SUBJECT: **INITIAL COMMENTS LETTER**

PROJECT NAME: FAMILY DOLLAR SALT SPRINGS @ CR 314

PROJECT #2021040075

APPLICATION: MAJOR SITE PLAN #26609

SHEET NUMBER:  
**C-04**

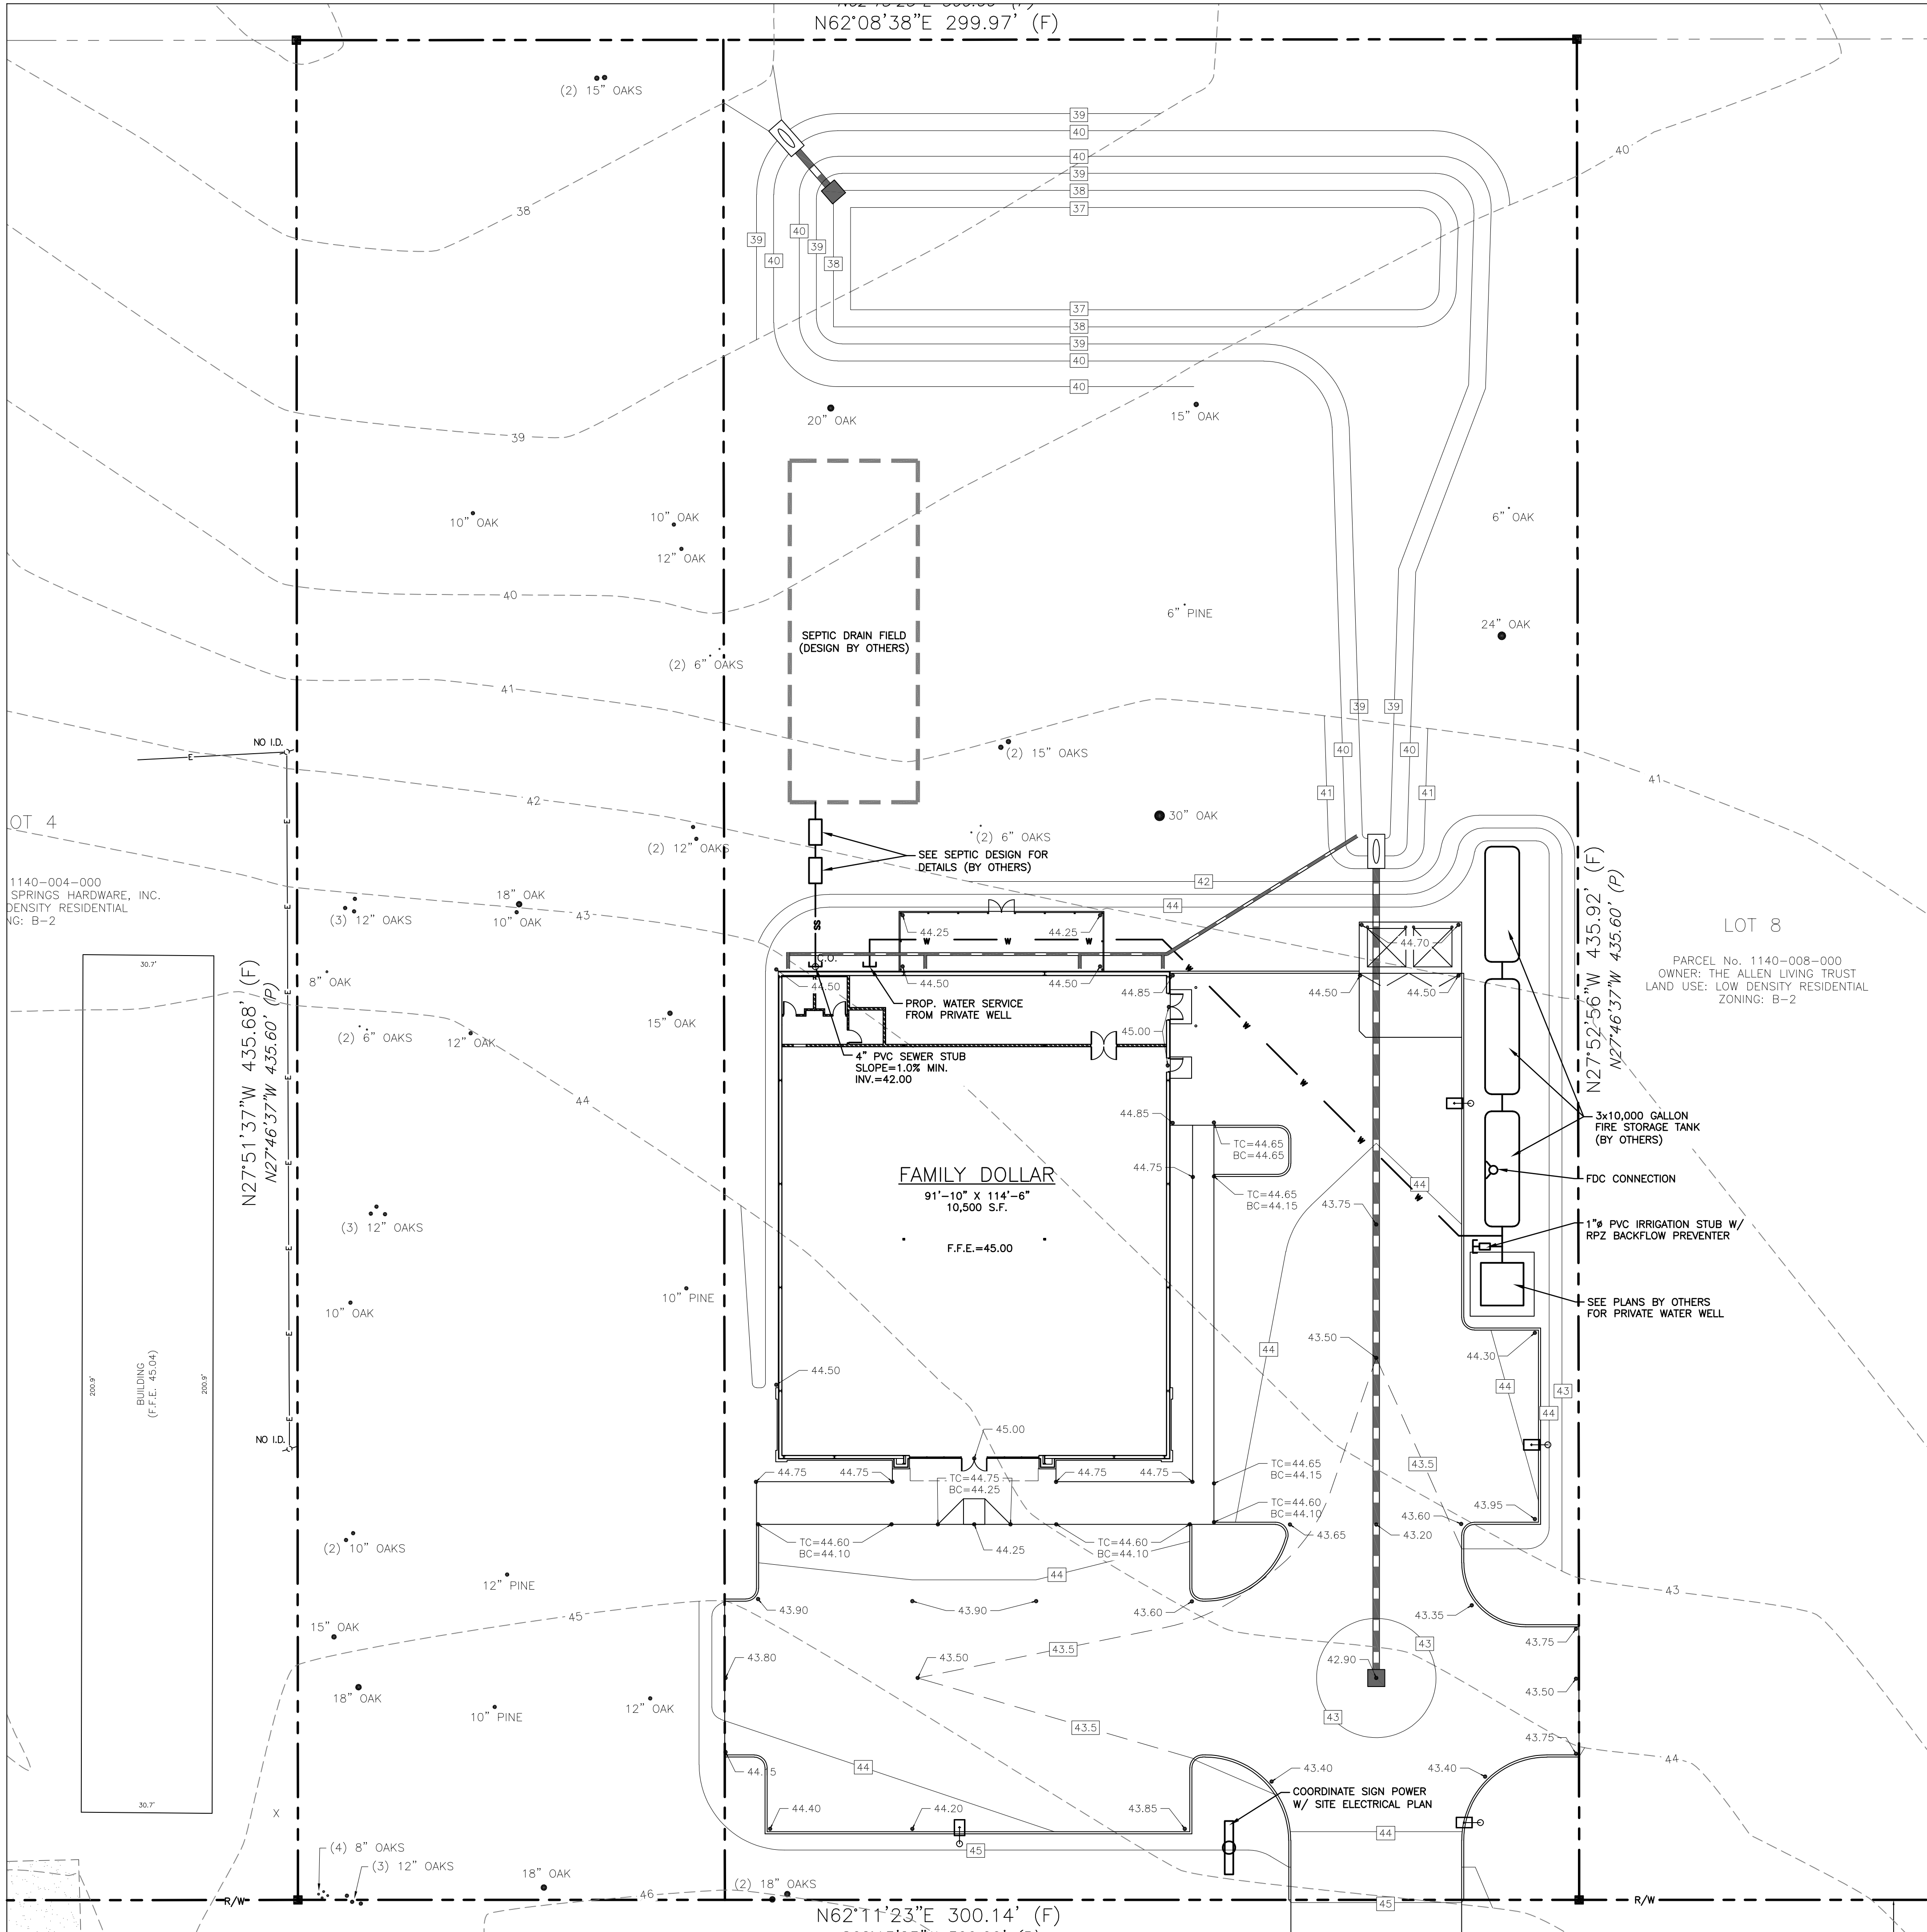
18. DEPARTMENT: ENGDRN - STORMWATER REVIEW  
REVIEW ITEM: 6.13.2.A(11)(b) - Erosion Control  
STATUS OF REVIEW: NO  
REMARKS: Please extend silt fence around to include the limits of pond construction.

L-01

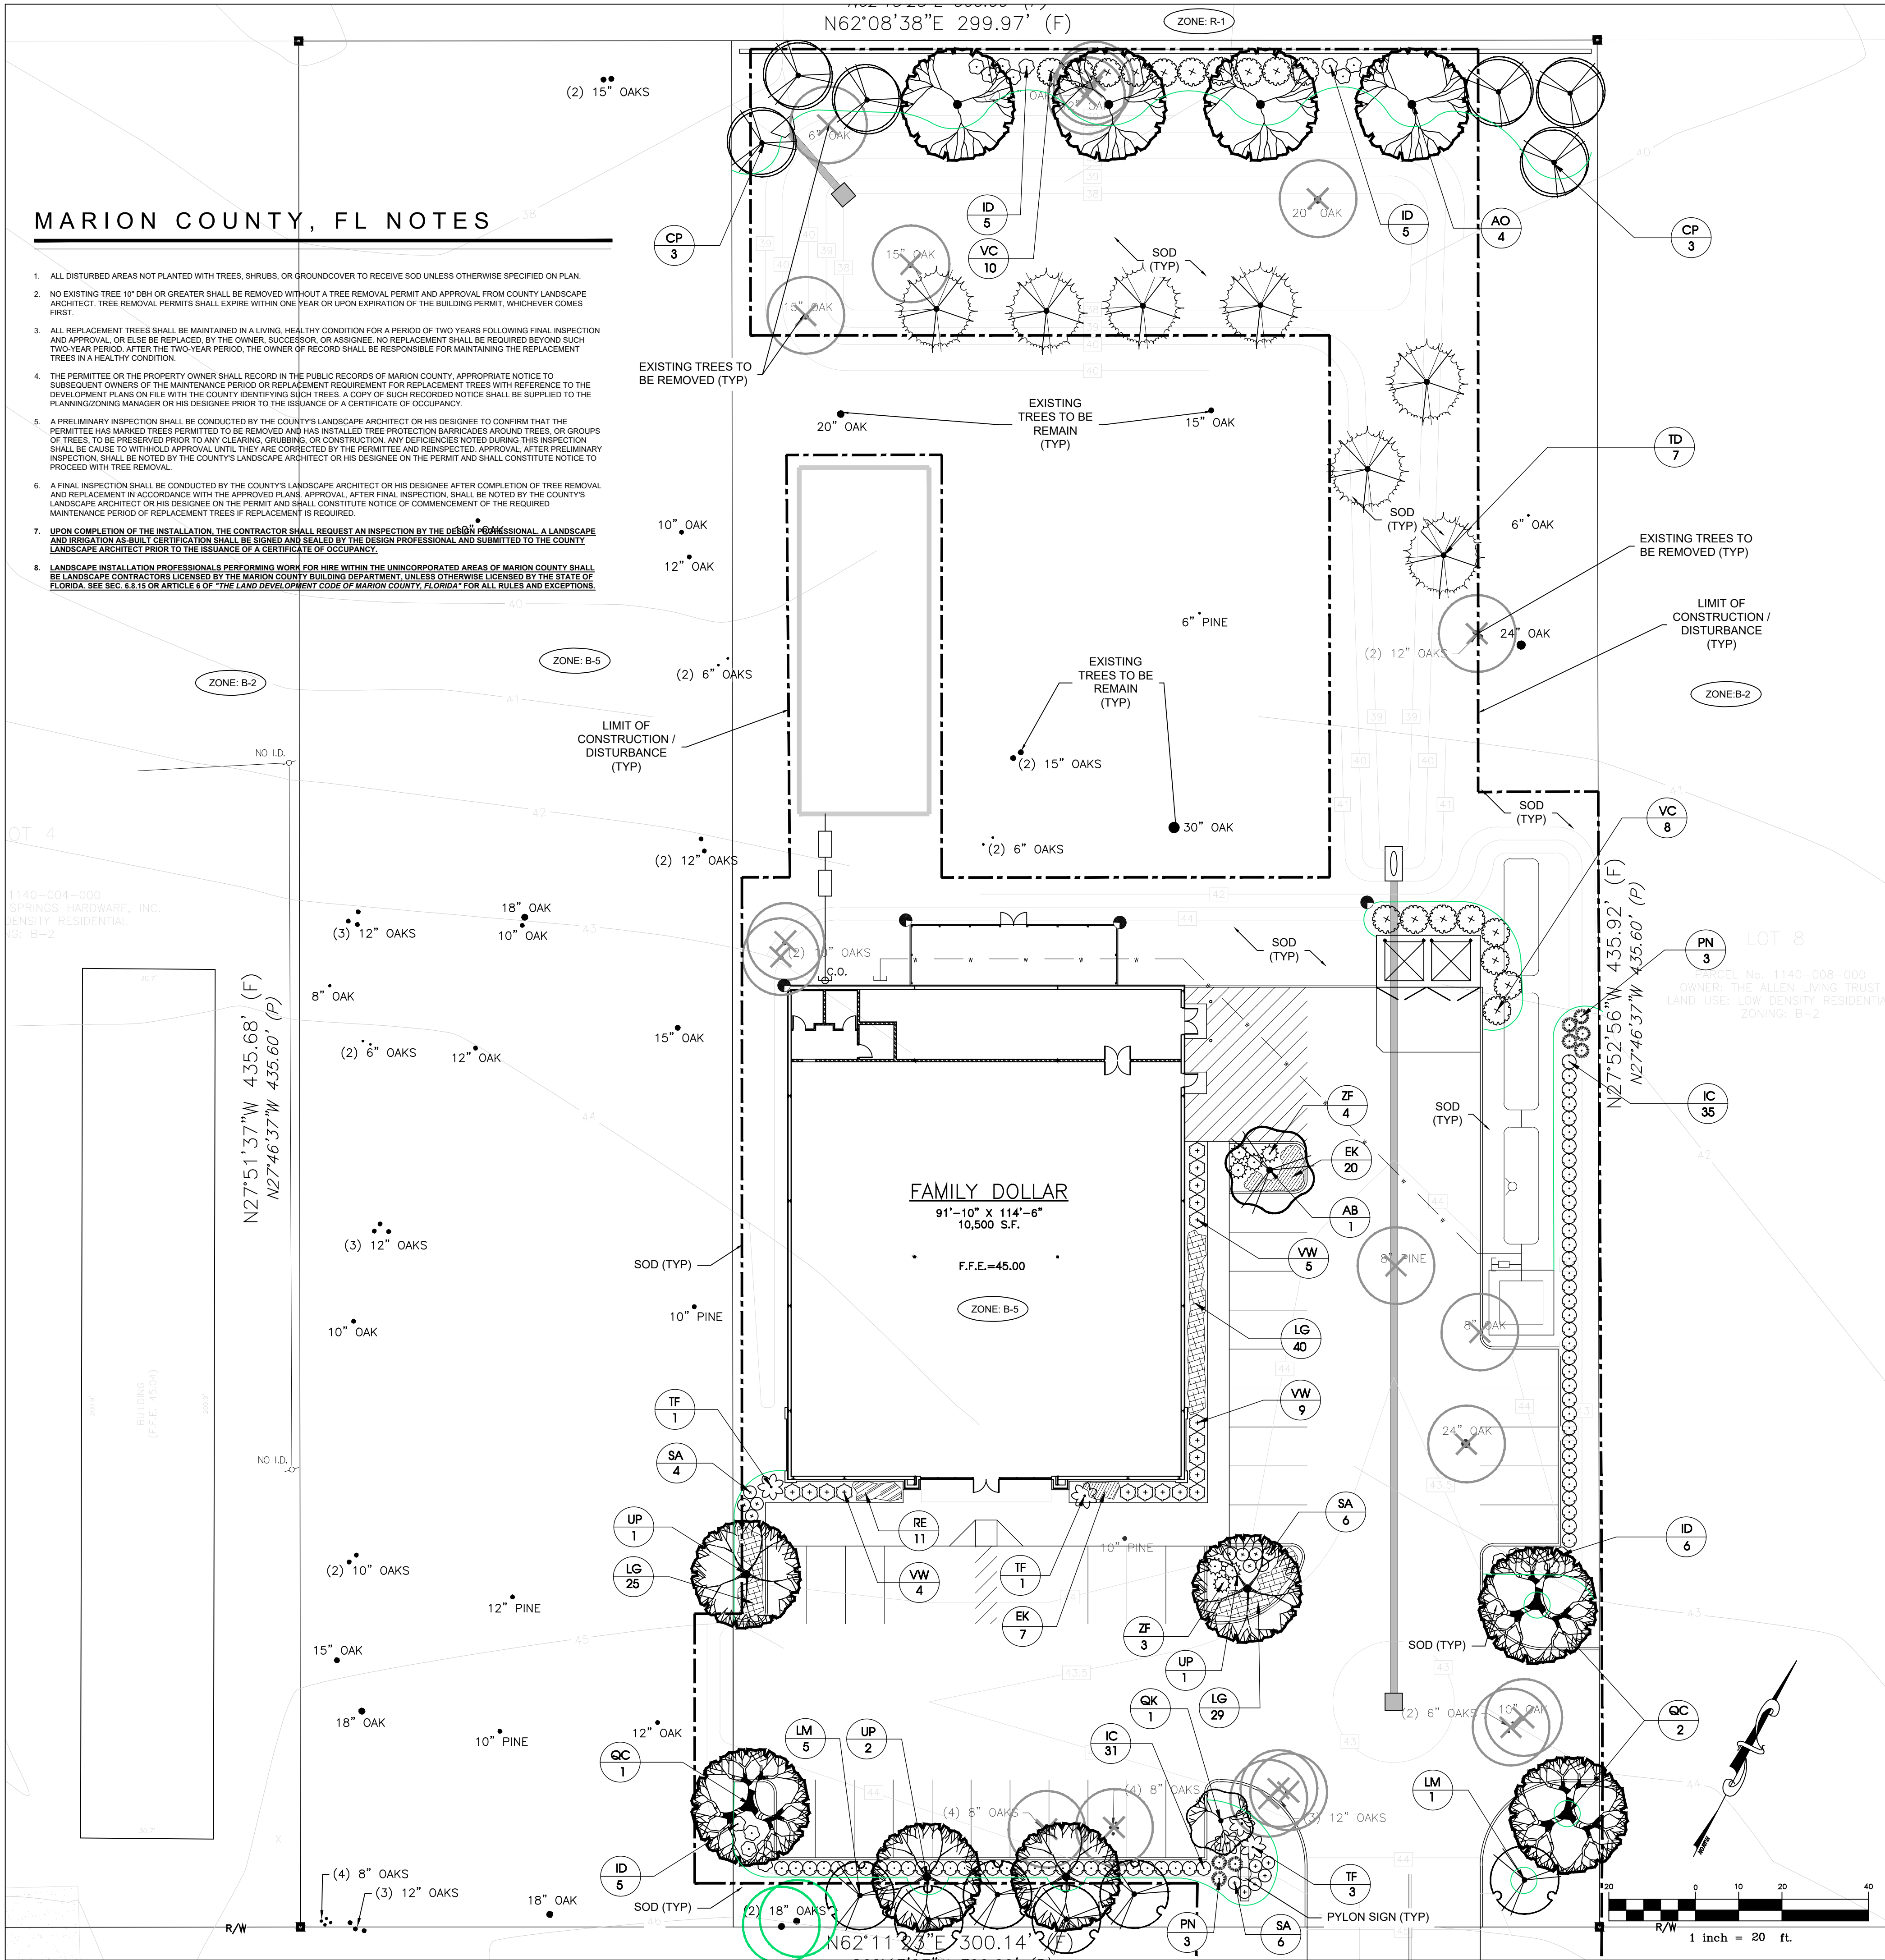
34. DEPARTMENT: 911 - 911 MANAGEMENT  
REVIEW ITEM: 6.2.1.F - North arrow and graphic drawing and written scale  
STATUS OF REVIEW: NO  
REMARKS: Sheet L-03 has two north arrows. The one furthest east is incorrect and needs to be removed.
